TRANS/WP.29/GRE/2003/23  
1 July 2003

Working Party on Lighting and Light-Signalling (GRE)

PROPOSAL FOR DRAFT AMENDMENTS TO REGULATION No. 98

(Headlamps with gas-discharge light sources)

Figure 1:

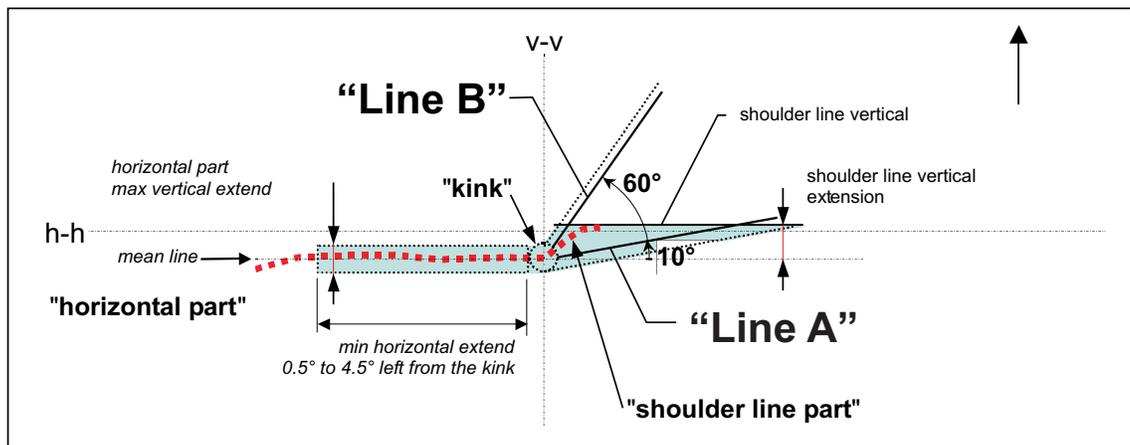
For visual adjustment of the passing beam the cut-off line shall provide a horizontal line for vertical adjustment of the headlamp between  $0.5^\circ$  and  $4.5^\circ$  distant from the v-v-line (see Figure 1), which does not exceed a vertical extend of  $\Delta\beta = 0.2$  degree up or down.

Figure 2:

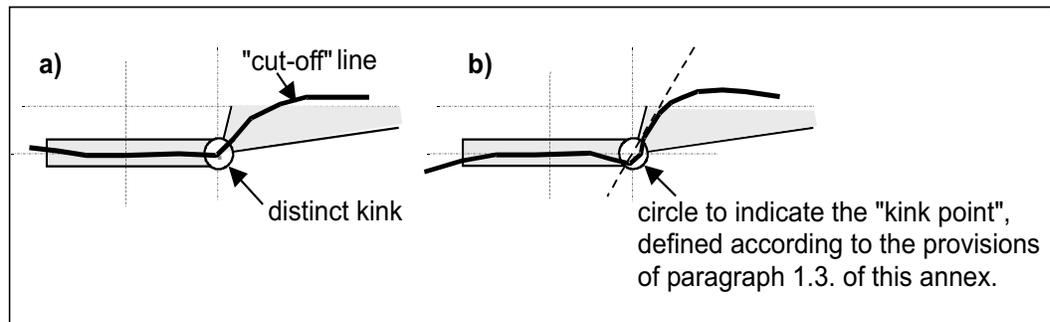
The beam with its the "cut-off" line shall be moved from right to left (left hand traffic: from left to right) until the "kink" or "elbow" is situated at the v-v-line. If the "elbow" forms no sharp enough edge, that point shall be taken, where the horizontal line through the straight part and the steepest tangential line onto the shoulder part of the cut-off line are crossing (for examples see Figure 2). The "shoulder line part":

- (a) does not extend the tangential line "B" going from the "kink" upwards to the right and being inclined versus h-h by  $60^\circ$ ;
- (b) does not extend the tangential line "A" going from the "kink" upwards to the right and being inclined versus h-h by  $10^\circ$ ;
- (c) has a vertical extension of at least  $\Delta\beta = 0.57^\circ$  over a distance of  $2^\circ$  to the left (right hand traffic) and  $2^\circ$  to the right (left hand traffic).

Figure 3:

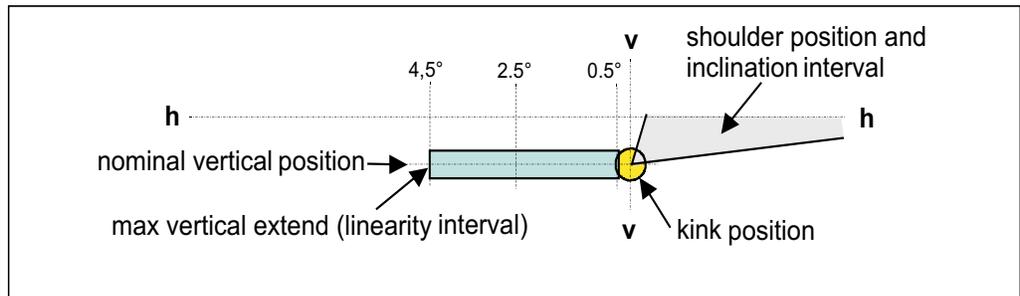
The part of the cut-off line which serves vertical adjustment shall be horizontal between 0.5° and 4.5° distant from the v-v-line. This requirement is deemed to be met when the vertical position of the inflection points (where  $d^2(\log E) / d\beta^2 = 0$ ) at 1.5°, 2.5° and 3.5° horizontal distance from the v-v-line are located within a band width of +0.2° from the nominal vertical position of the cut-off line at 2.5° sideward of the v-v-line, see Figure 3.
